**Re: Detrex Corporation Source Area (OU5) – Fields Brook
Superfund Site, Ashtabula, Ohio**

FBAG Comments on URS Report Dated May 24, 2012

Fields Brook Superfund Site, Ashtabula, Ohio

Comments on Detrex Source Investigation

Locations of Soil Borings with Visual Evidence of DNAPL

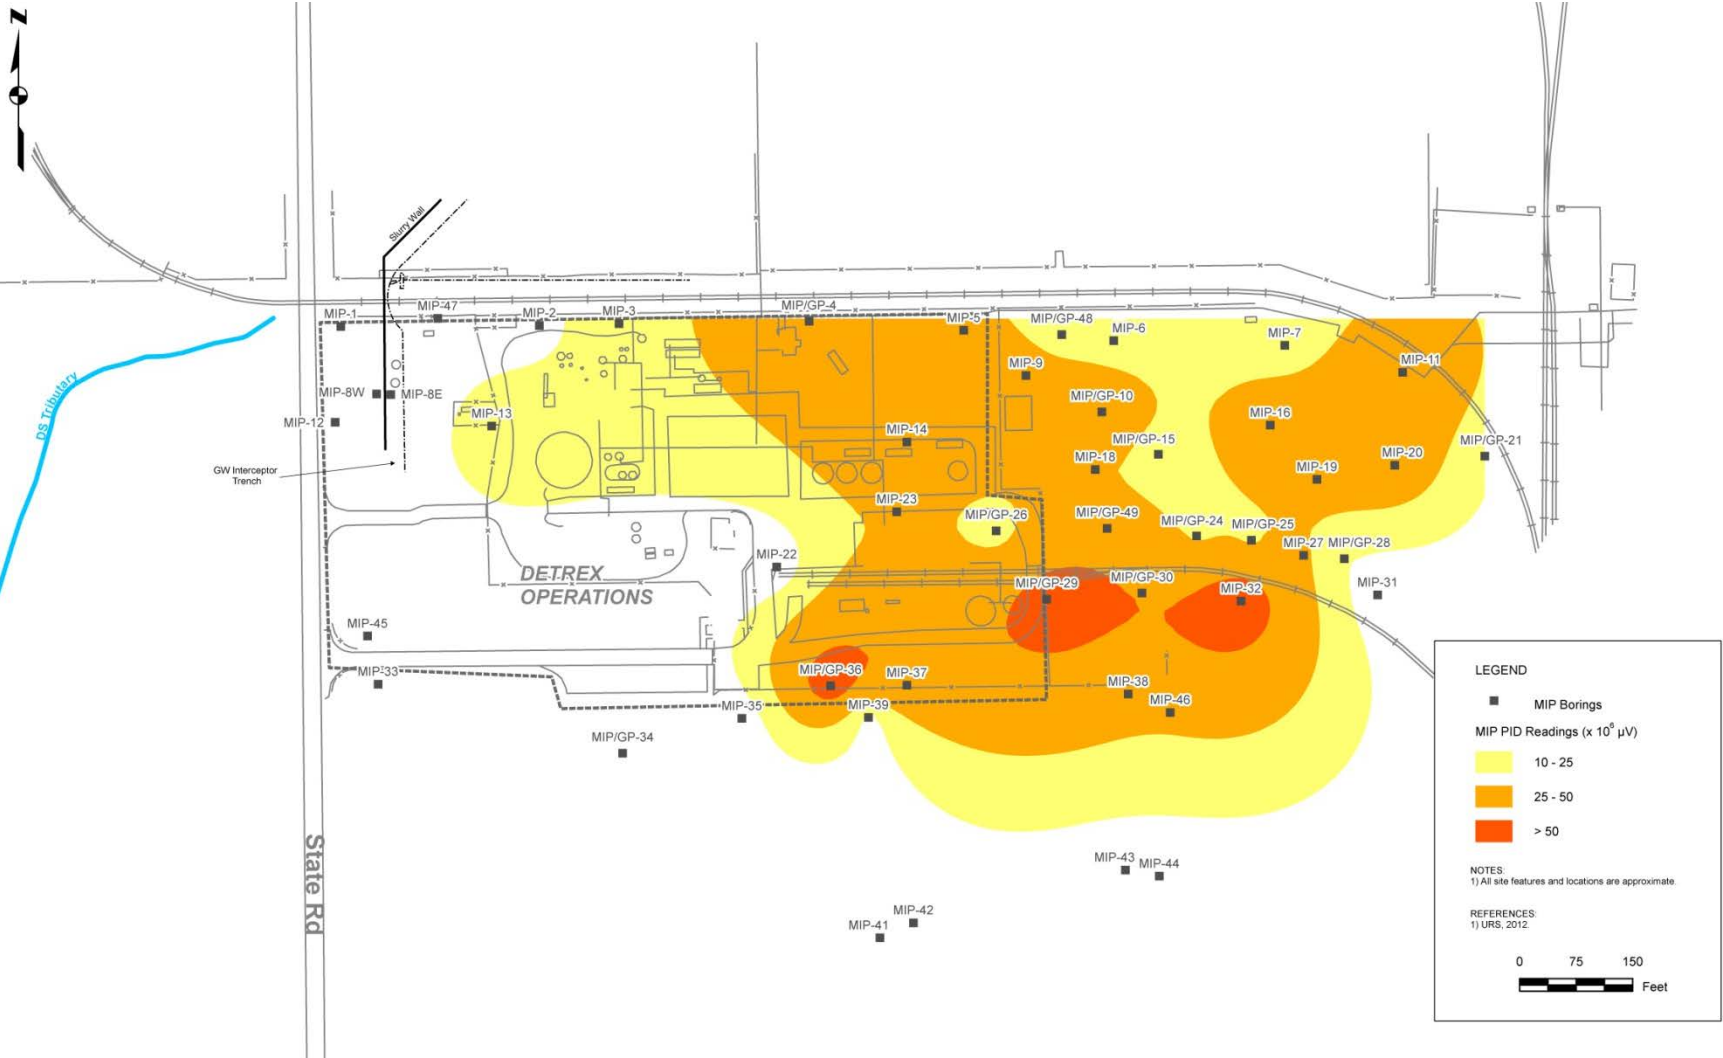
- Detrex conclusion that “there is no evidence of thick extensive zones or layers of DNAPL anywhere on site” is not consistent with the study’s findings
 - Although borings are not the ideal DNAPL investigation tool, DNAPL was found in 13 out of 20 borings
 - At least 2 feet of DNAPL seeps/sheens/ganglia discovered at several locations (e.g., GP-15,-16,-48)
 - Strong evidence indicating presence of significant amount of DNAPL on Detrex property

MIP Survey Results

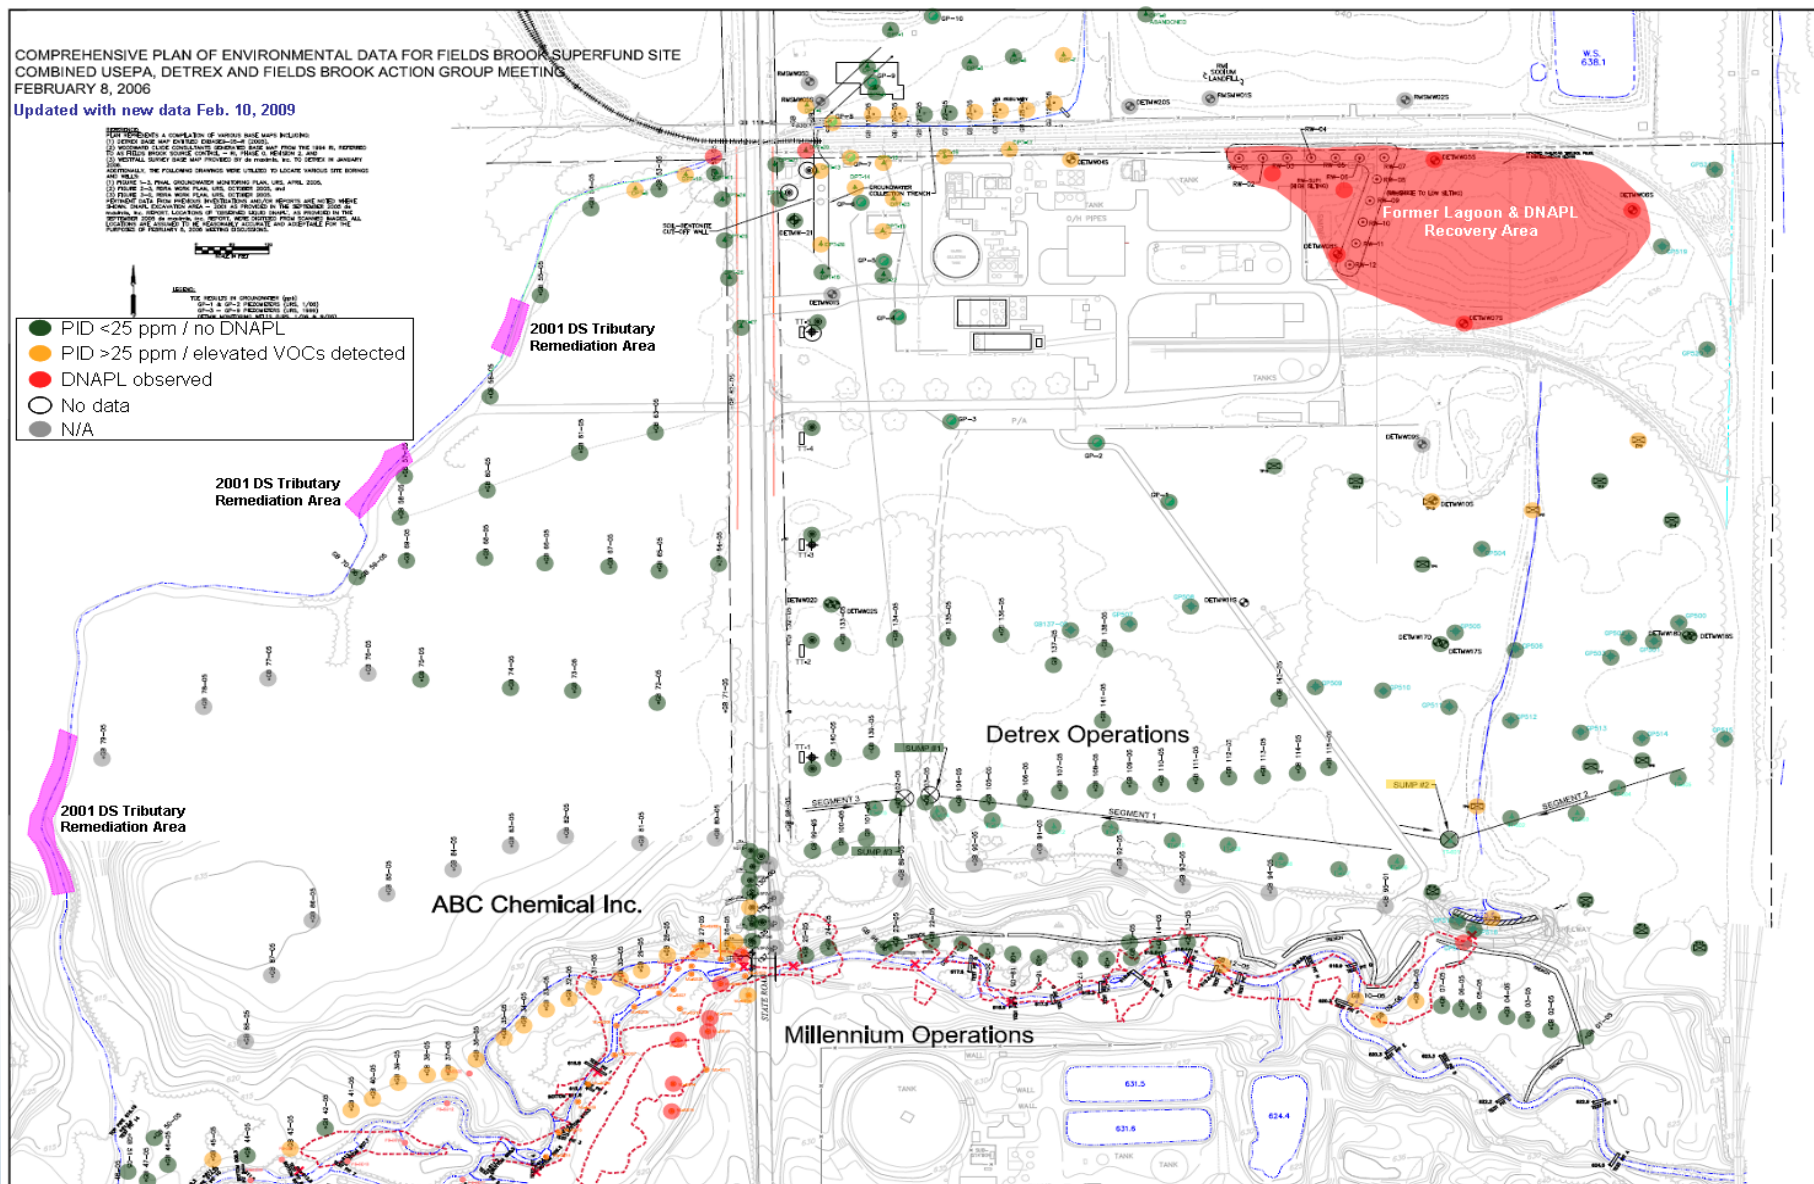
- Source investigation results confirm that significant quantity of recoverable DNAPL is present at the Detrex facility
 - DNAPL found in a majority of soil borings
 - MIP results define spatial extent of source area
- Detrex DNAPL is a Principal Threat waste – as discussed in the ROD and Five Year Review – and needs to be removed and treated
- Detrex should implement the ROD remedy of aggressive DNAPL removal and treatment

DNAPL Accumulation in Detrex Monitoring Wells

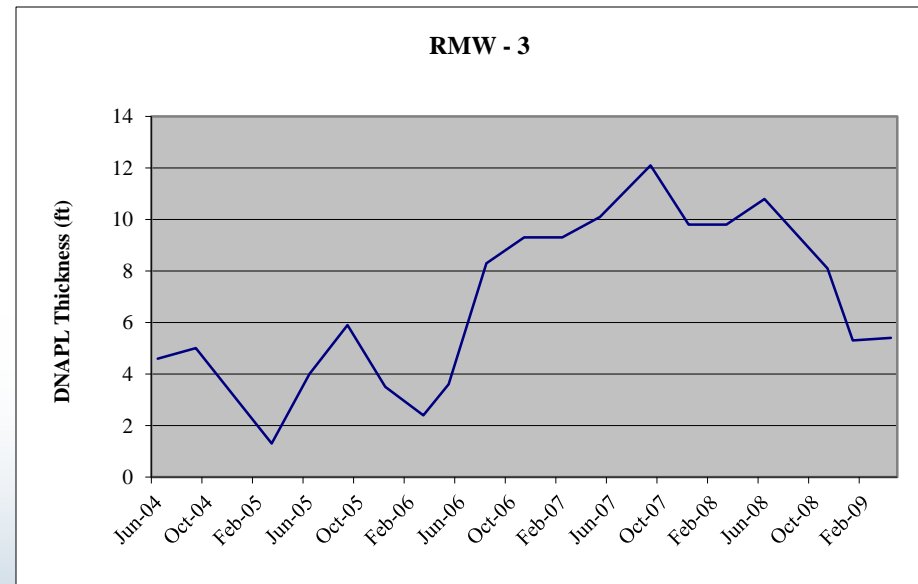
➤ Persistent accumulation of several feet of DNAPL in monitoring wells indicate the presence of a significant volume of mobile DNAPL on the Detrex property
